WILSON ARCH SPECIAL SERVICE DISTRIC WATER IMPROVEMENTS 2022  
Addendum 1  
January 5, 2024

Bid Schedule – Addendum 1  
Sheet TD1 – Tank Details

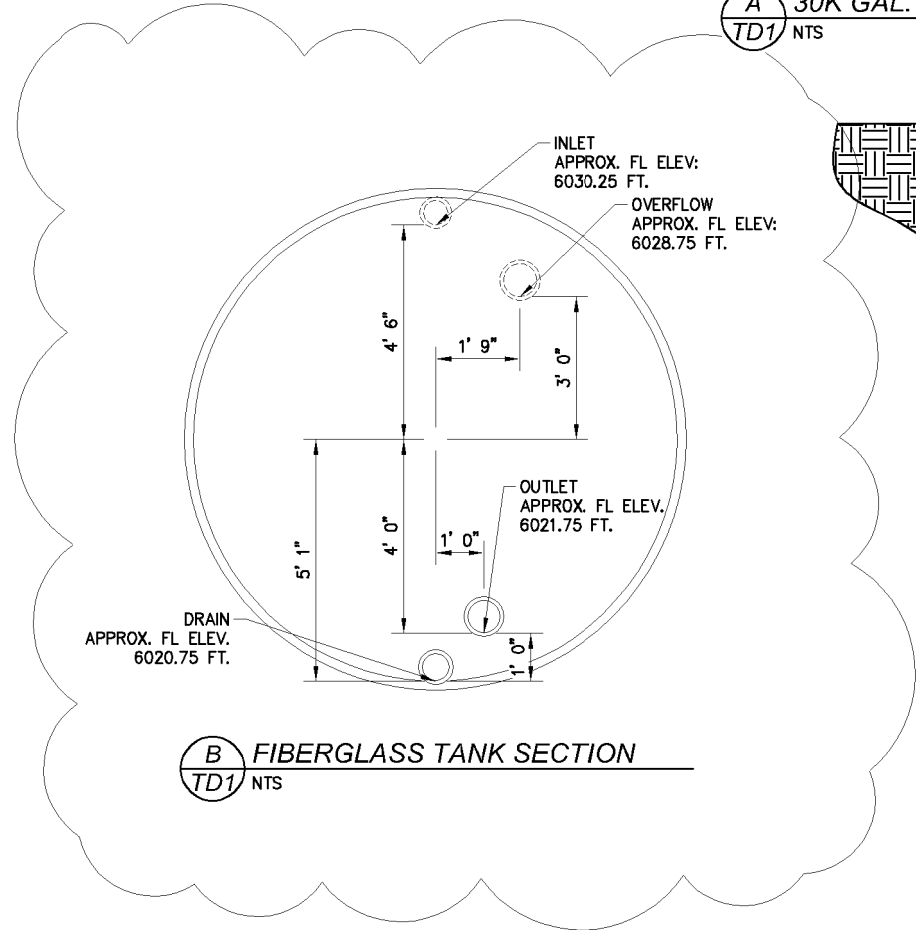
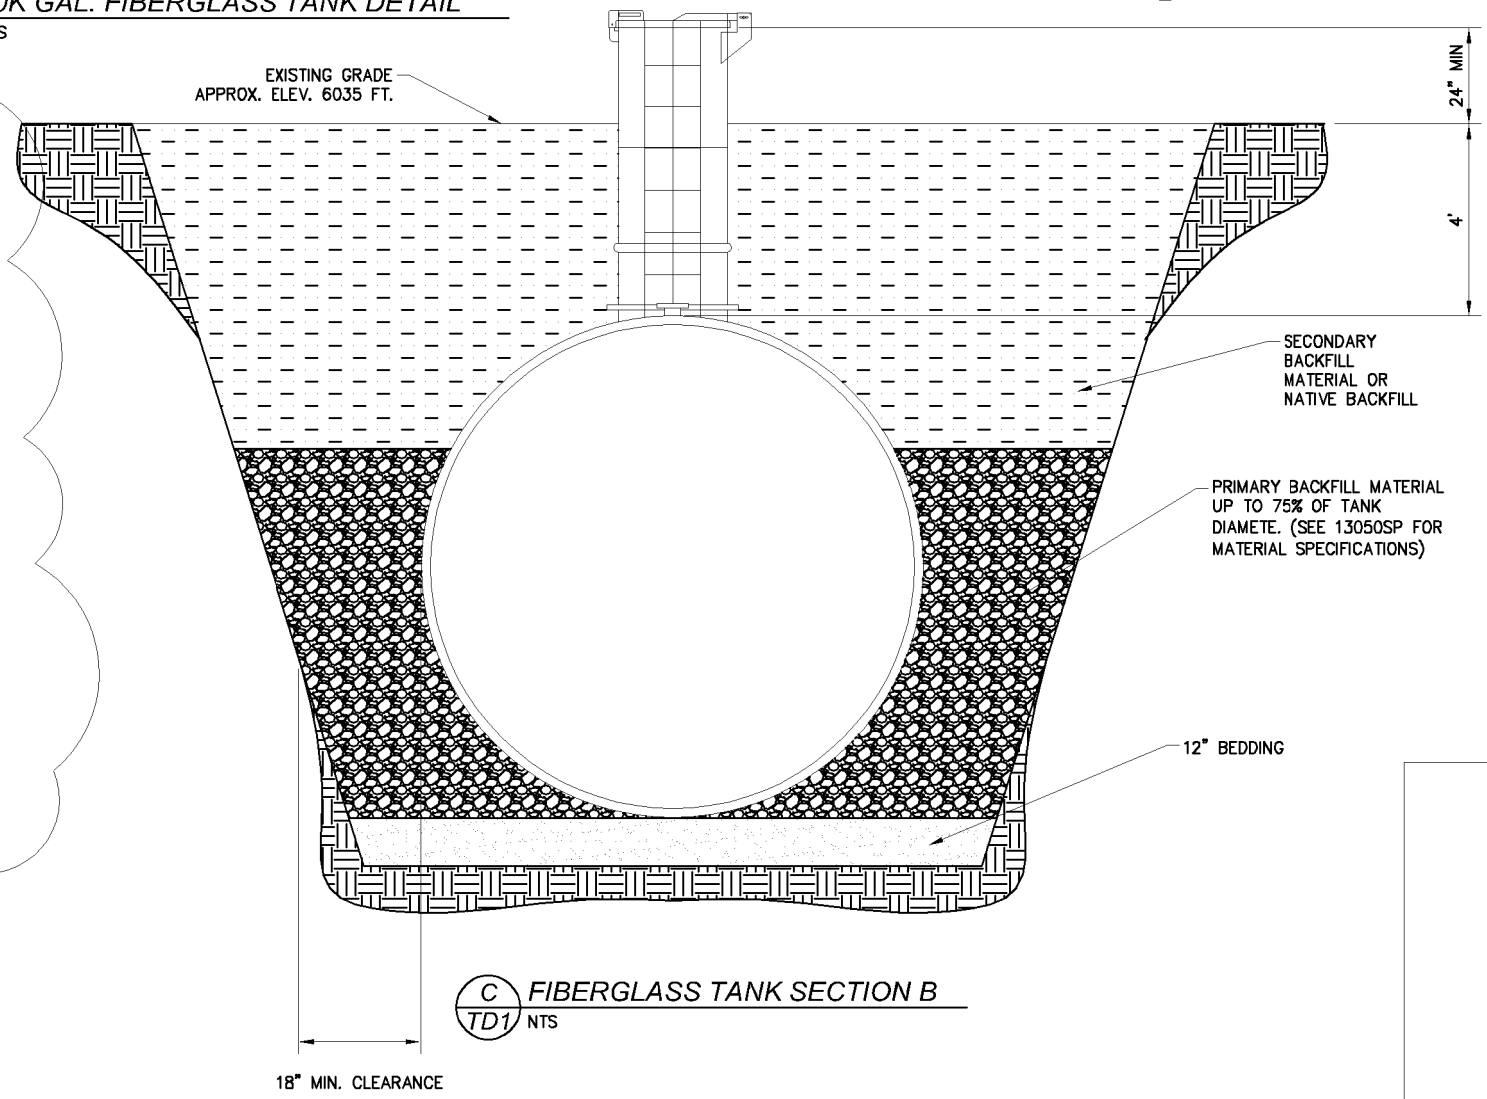
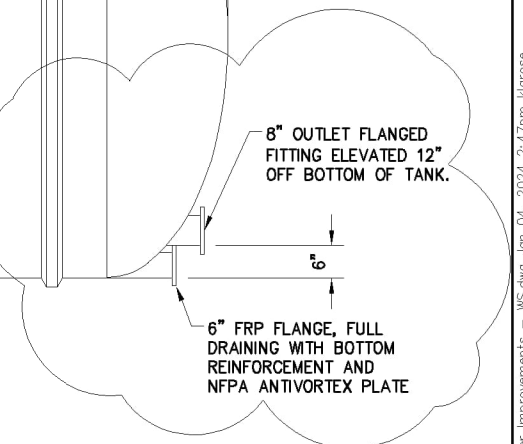
2. Revisions to the Plans:
  - a. A revised detail for the new fiberglass storage tank is attached. The revisions to the detail include:
    - i. The drain pipeline coming out of the tank has been revised based on manufacturer recommendations. This may affect fittings needed.

- ii. Access ladders are more clearly shown as going into the tank.
3. Statement on BABA Requirements:
  - a. A supplier has expressed concern regarding finding BABA-compliant products/materials for the pumps, VFDs, pitless adapters, and residential radio read meters. The Contractor is required to follow all BABA requirements in the Contract Documents.
